VISION STATEMENT

**CITY OF WACONIA
JUNE 2ND, 2022**

Meeting Date:		July 7, 2022				
Item Name:		SITE PLAN & DESIGN REVIEW - Darabi Dermatology - submitted by Stephen Paetzel, Mohagen Hansen Architectural Group				
Originating Department:		Community Development				
Presented by:		Ethan Nelson				
Previous Council Action (if any):		Planning Commission recommendation of approval for Site Plan and Design Review for Darabi Dermatology via a 4-0 vote.				
Item Type (X only one):	Consent		Regular Session	X	Discussion Session

Meeting Date:		July 7, 2022				
Item Name:		PUBLIC HEARING – Woodland Creek 5 th Addition Preliminary Plat and				
Originating Department:		Community Development				
Presented by:		Ethan Nelson				
Previous Council Action (if any):		Planning Commission tabled the Preliminary Plat and Rezoning Request during the May 5th, 2022, regular session.				
Item Type (X only one):	Consent		Regular Session	X	Discussion Session

Grading and Erosion Control Plan

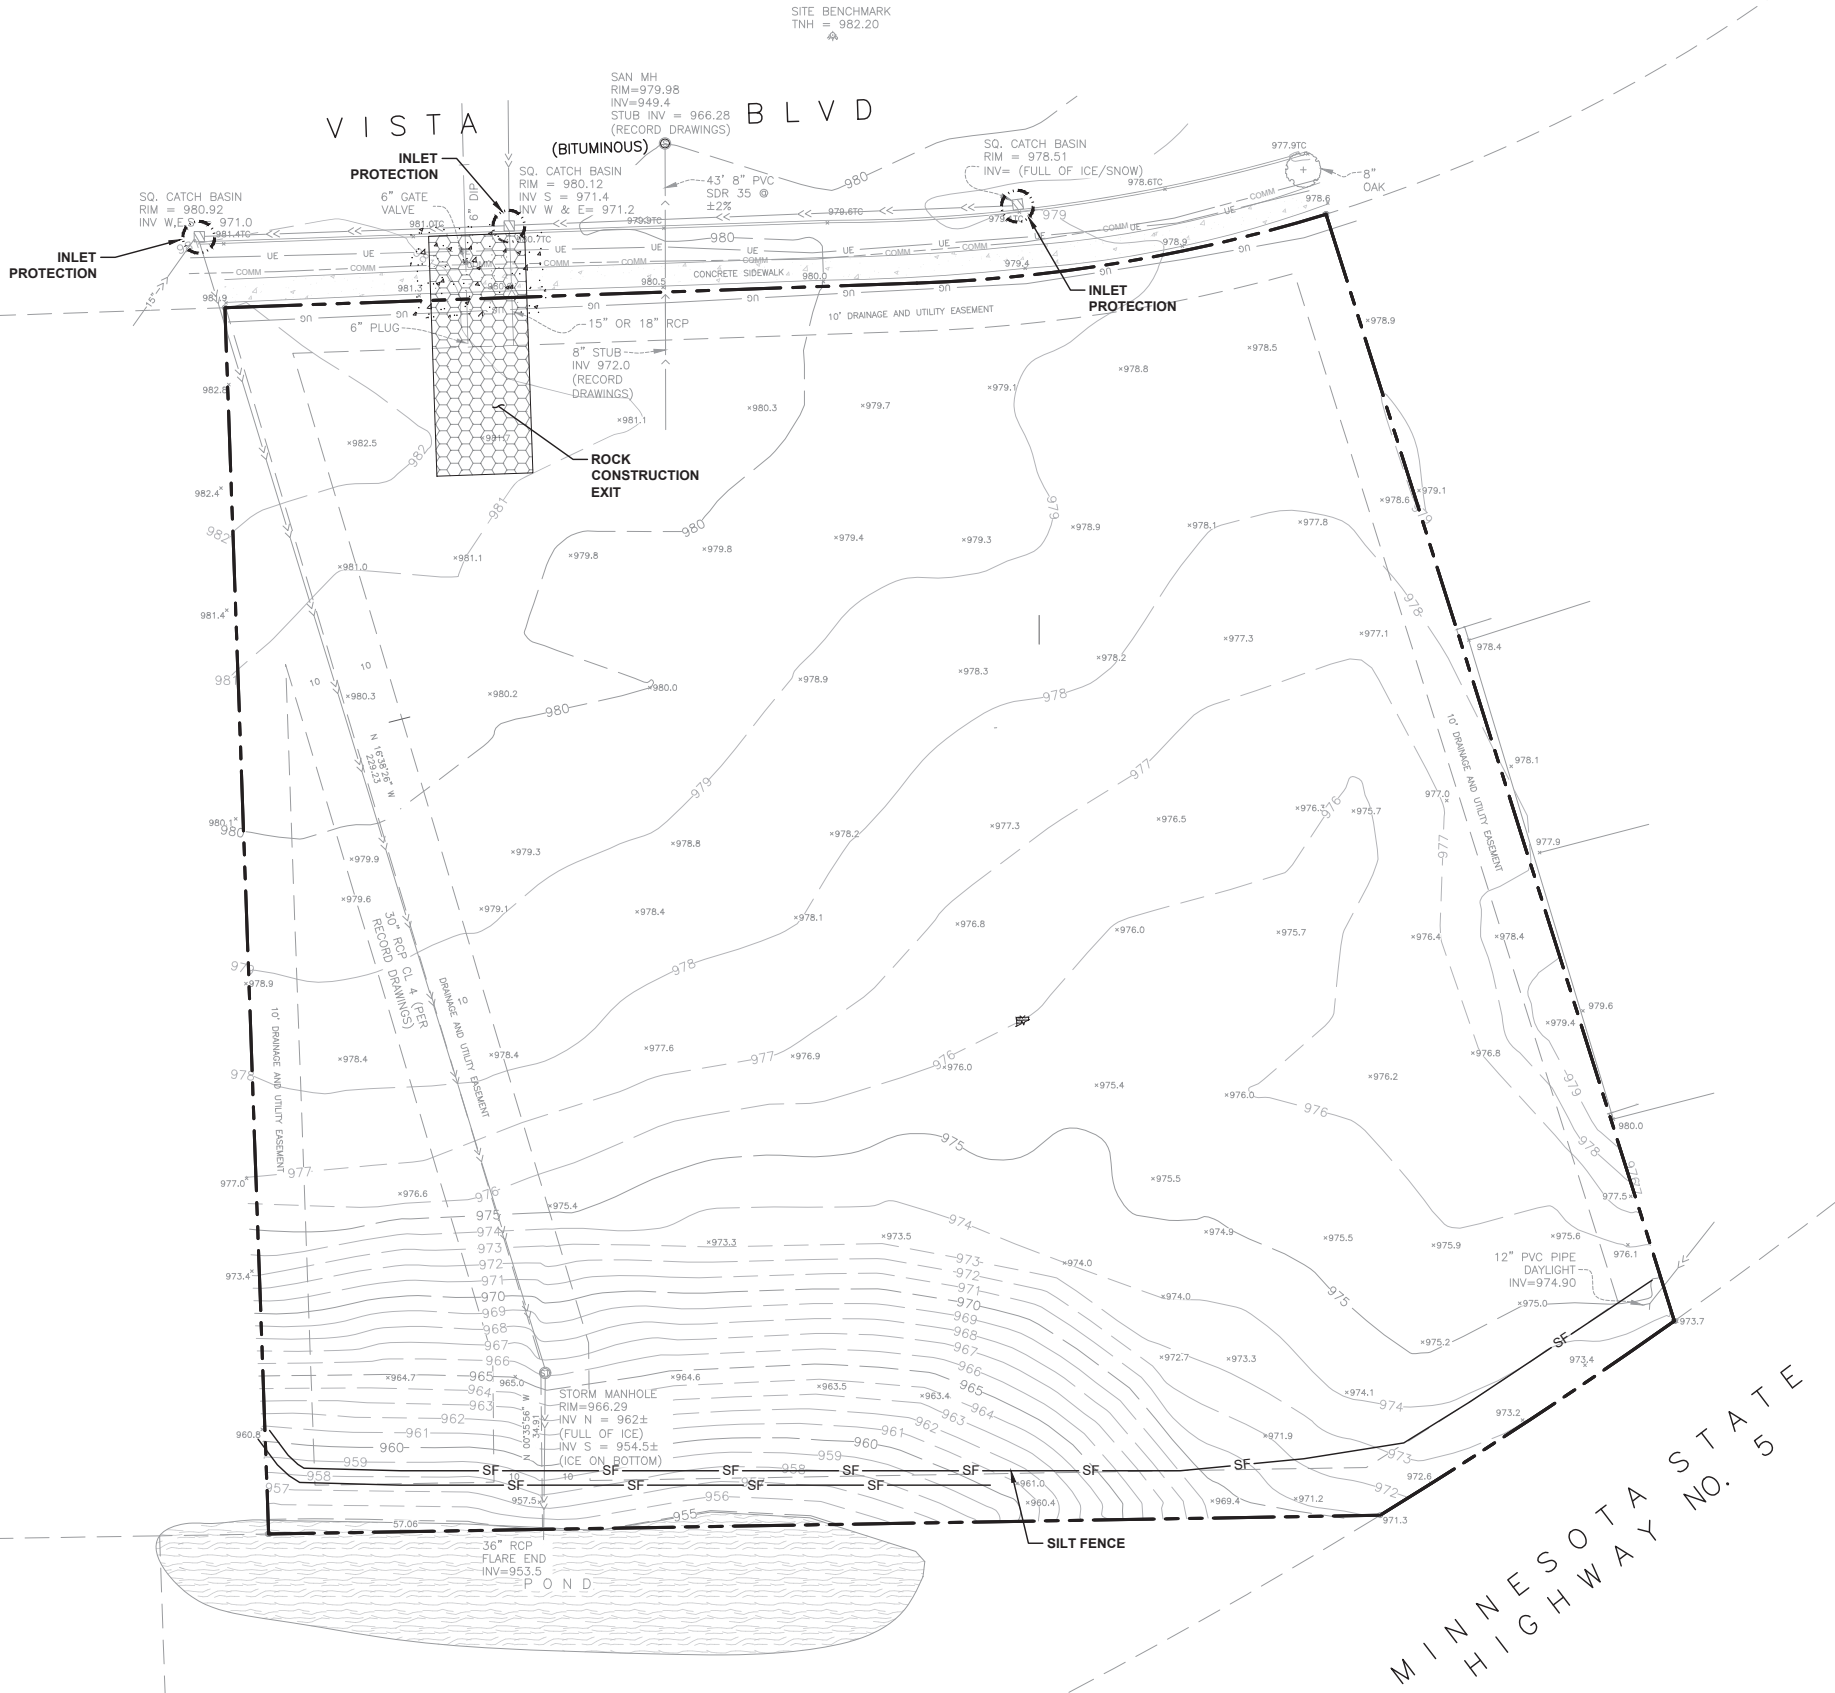
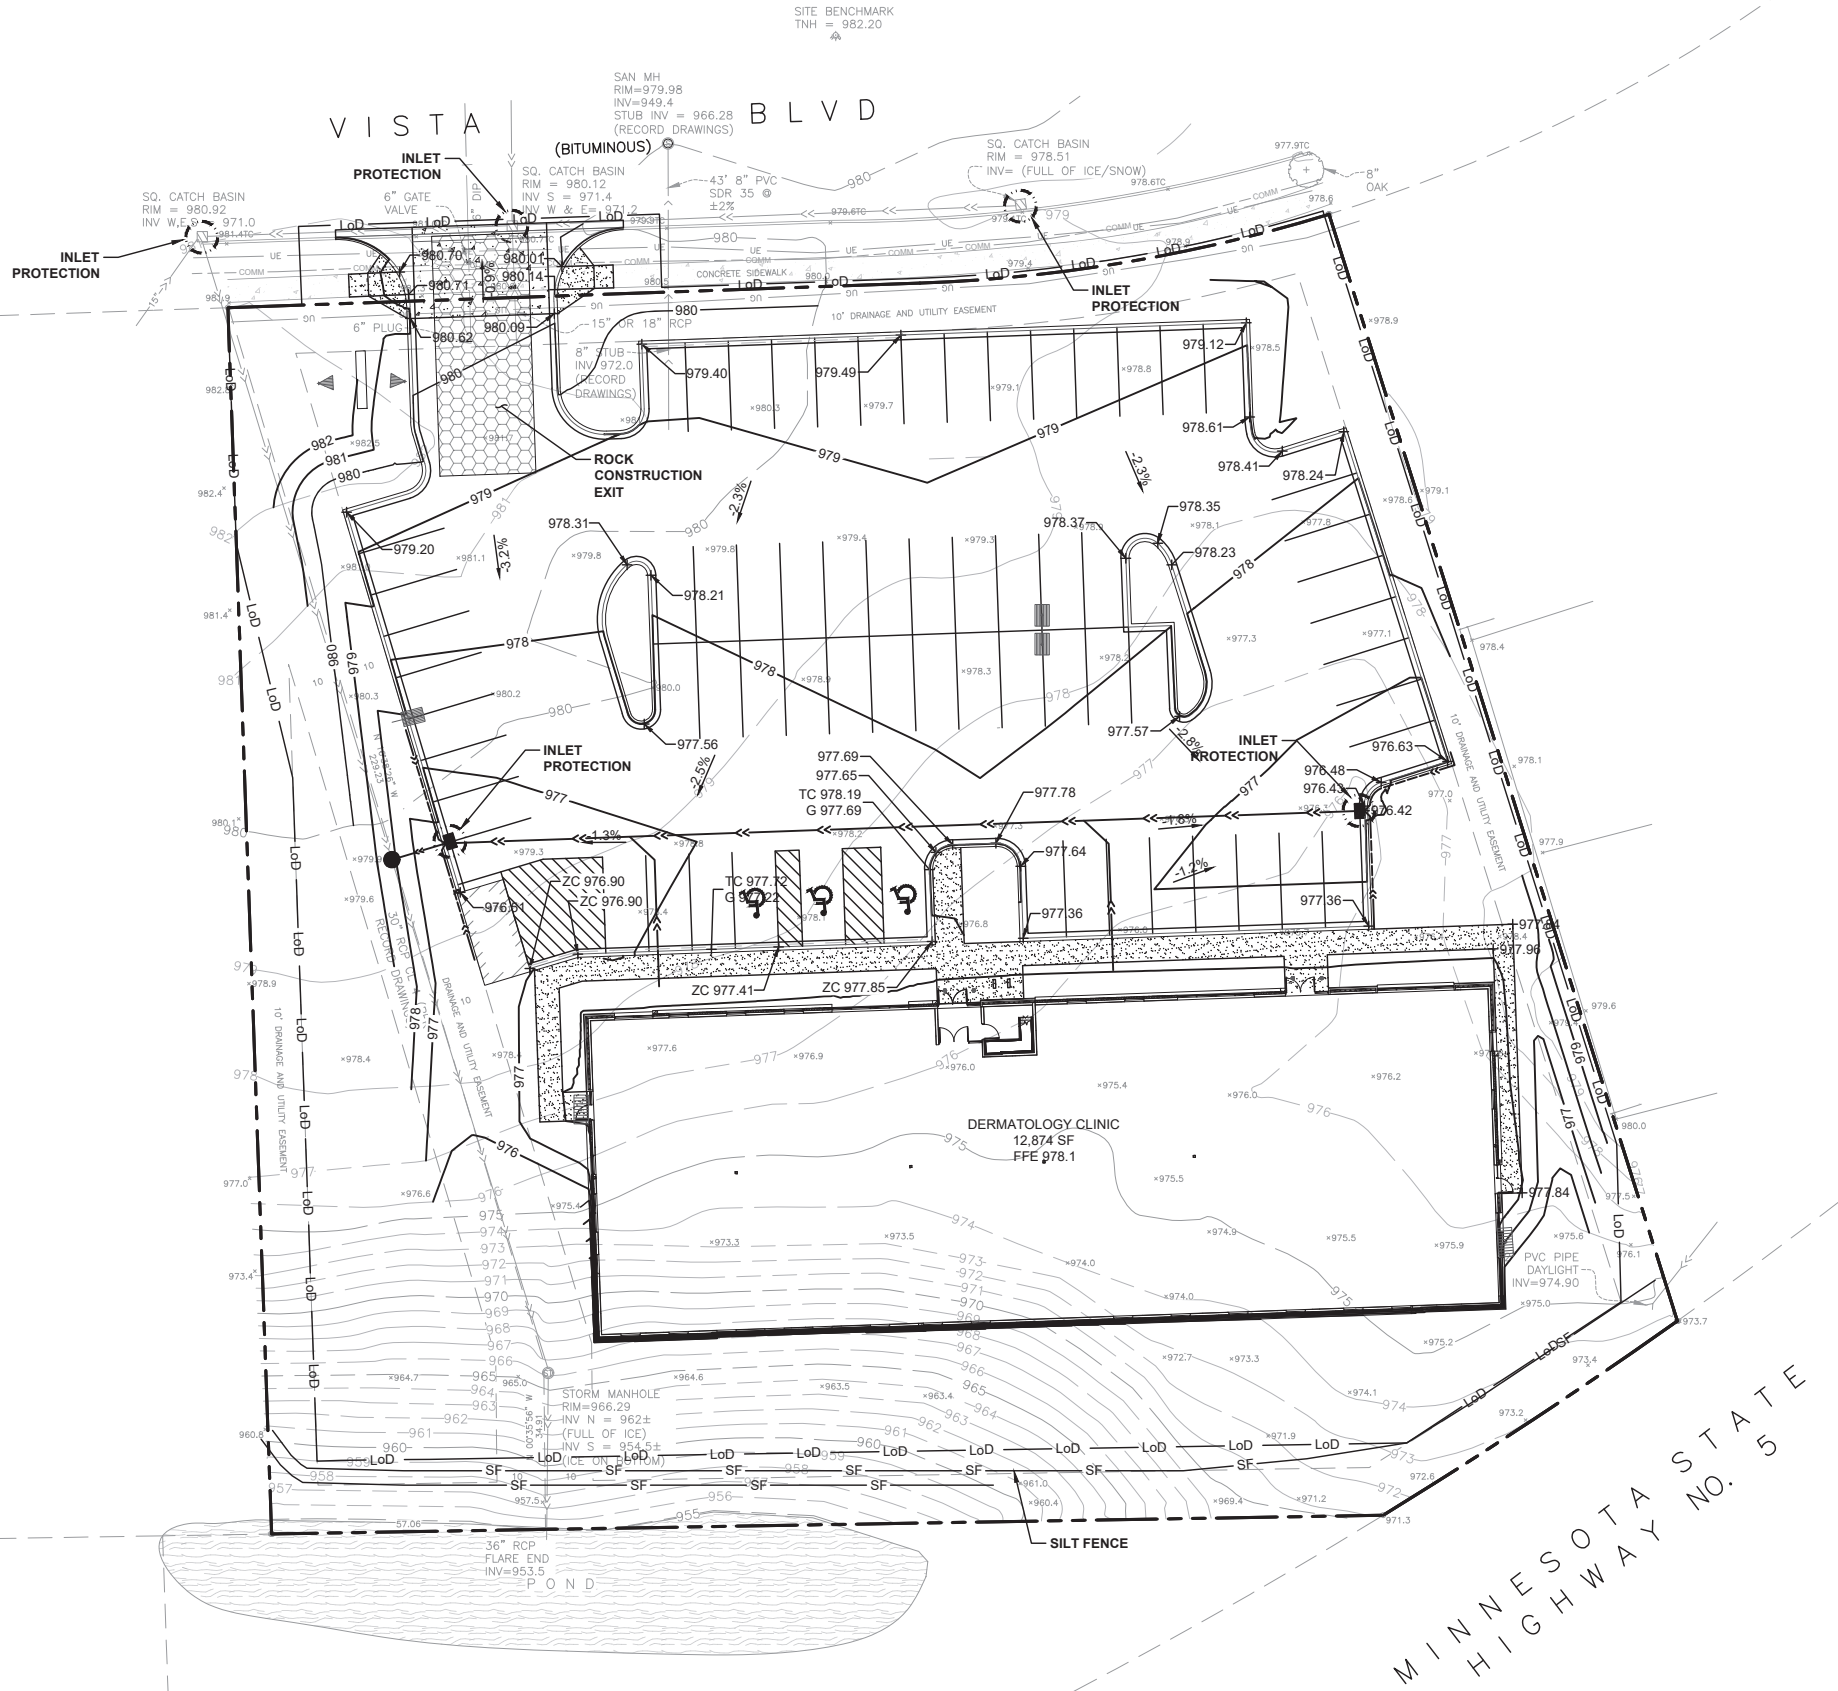
9. Perimeter erosion control measures should be installed by the contractor and inspected by the City prior to any other work. Contractor must provide 24-hour notice prior to inspection.
10. A SWPPP review checklist is required and is attached.

SITE PLAN

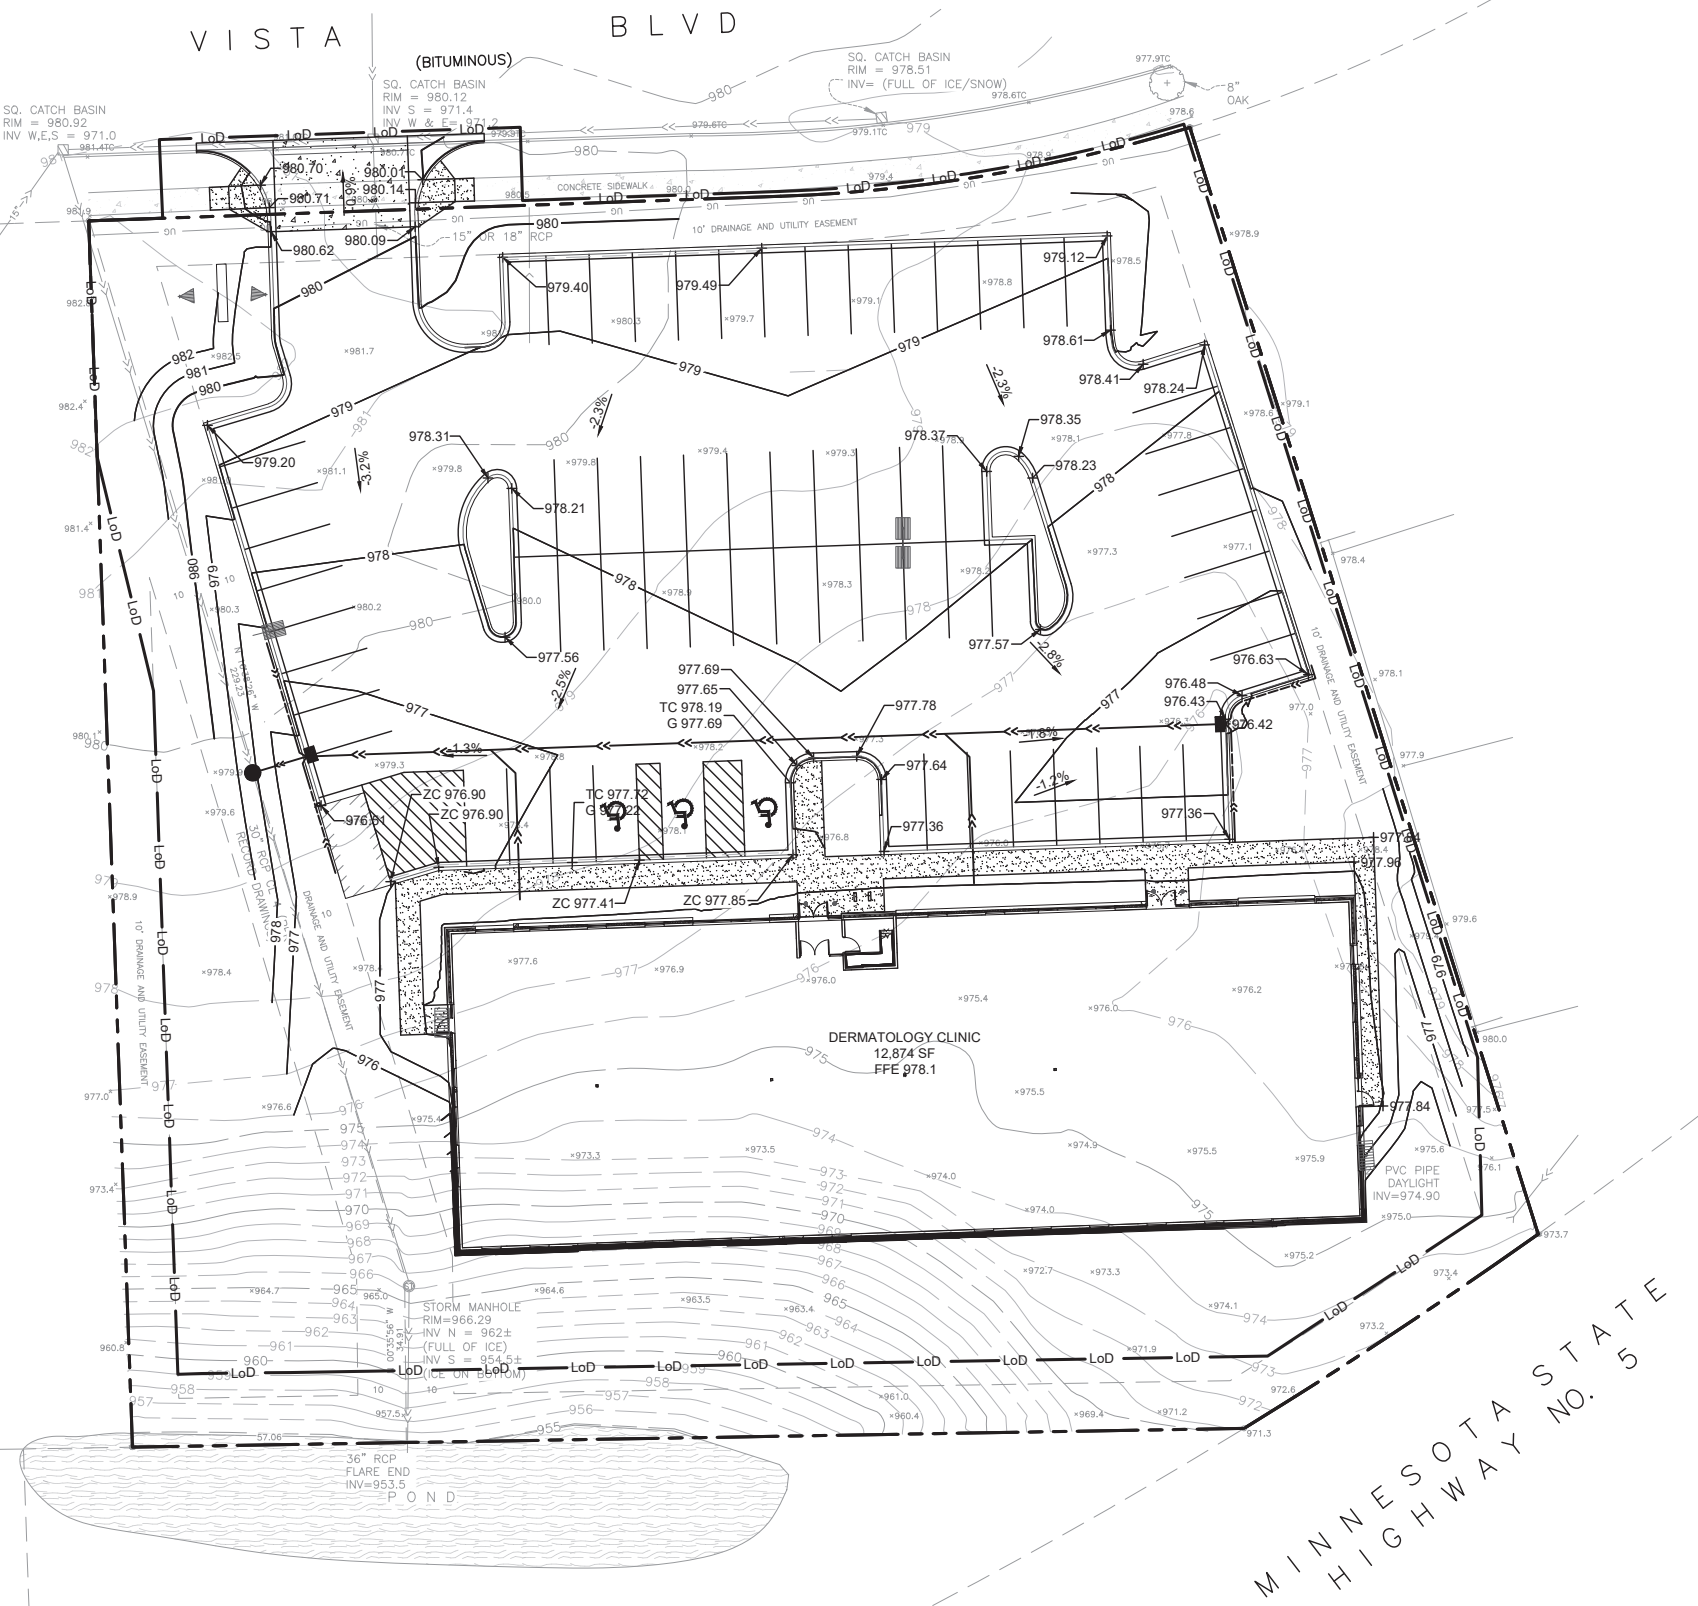
Site Plan
